Part 21 (PAR)

Event # 49923

## PART 21 - BEARING DEFECT

**FINAL REPORT 10CFR PART 21  
REPORT OF A POTENTIAL SAFETY HAZARD**

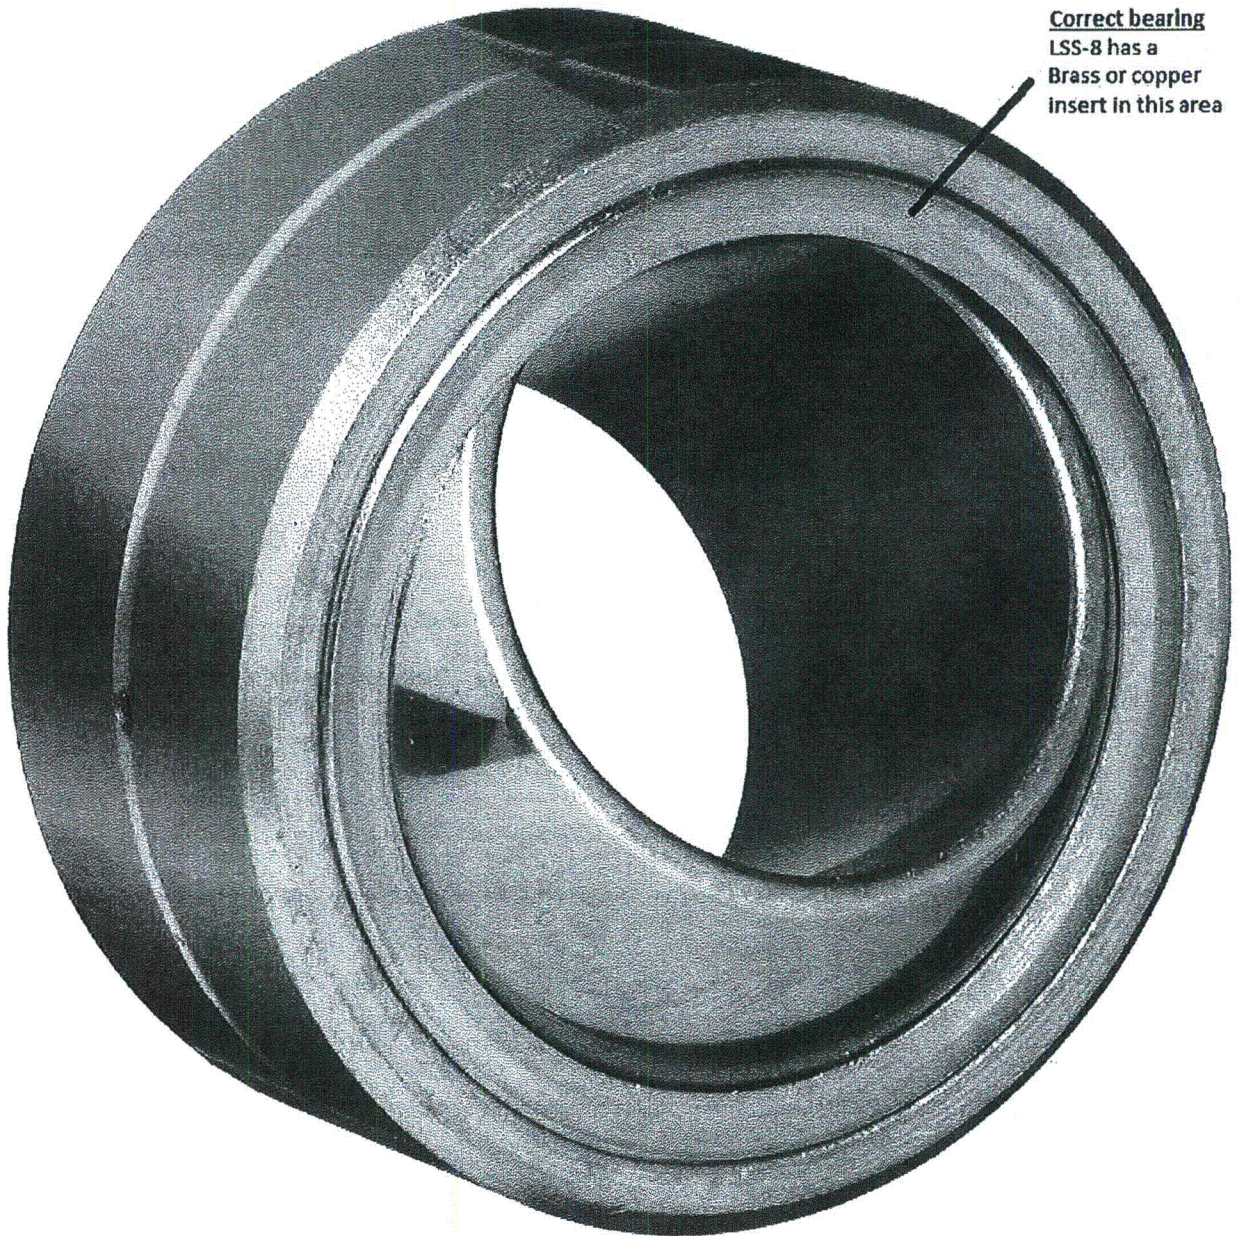
Correct bearing  
LSS-8 has a  
Brass or copper  
insert in this area

There are 18 turbines tabulated on page 2 that use this bearing, all have PG type mechanical governors.	
<b>4. CORRECTIVE ACTION BY:</b> <u>Staff</u>	<b>COMPLETED BY</b> <u>4/16/14</u>
The Part Design record was updated to emphasize copper alloy insert and the Inspection record was changed to require the vendor part number be recorded on the inspection form.	
<b>5. ADVICE TO AFFECTED CLIENT RELATED TO THIS REPORT</b>	
The customer should visually inspect this bearing for the bronze insert. See picture on page 3. If no insert is visible then the bearing should be replaced at the first opportunity.
